SUBJECT: Part 21 rept re possible machining defect in certain one inch stainless steel Swagelok front ferrules, part number SS-1613-1. Caused by tubing slipping out of fitting at three times working pressure of tubing. Notified affected utils.

Subject: Defects Potentially Reportable Under 10CFR21

We are writing to inform you about a possible machining defect in certain one inch stainless steel Swagelok front ferrules, part number SS-1613-1.

ACCEPTABLE

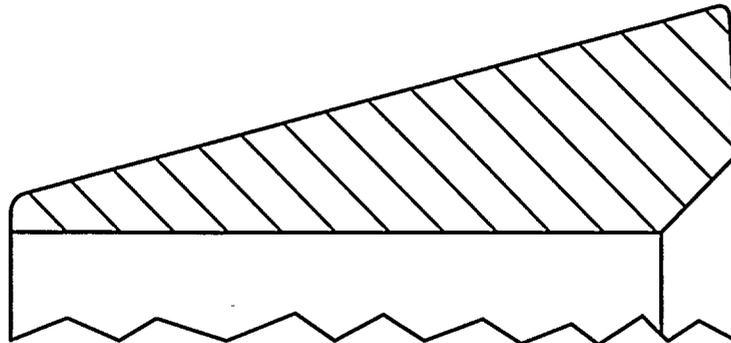
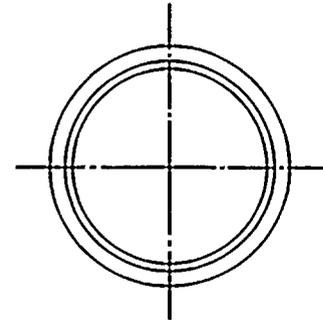
The possible defect is that the 45 degree chamfer on the trailing edge of the ferrule may not be correct. A drawing is enclosed that shows this dimension, along with a drawing that illustrates the front ferrules' position in the Swagelok tube fitting. When these ferrules were machined, an improper set-up allowed a few pieces to be manufactured with an inappropriate dimension. Our inspection of the lots involved shows that about 0.019 per cent of the ferrules manufactured in these lots were affected.

NOT ACCEPTABLE

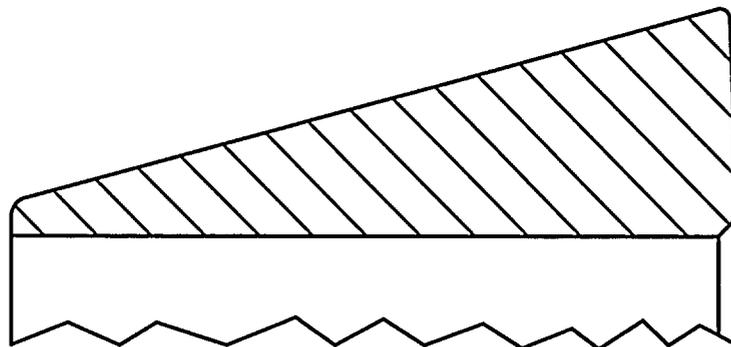
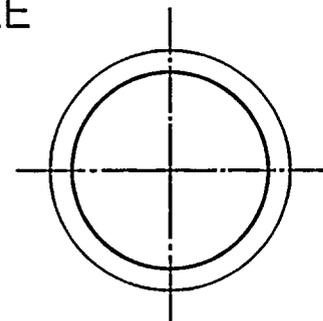
Laboratory testing of these parts with this incorrect dimension had the tubing slip out of the fitting at three times working pressure of the tubing.

Our corrective action includes doubling our sample size on these parts and implementing a long term project to 100 per cent inspect using automation.
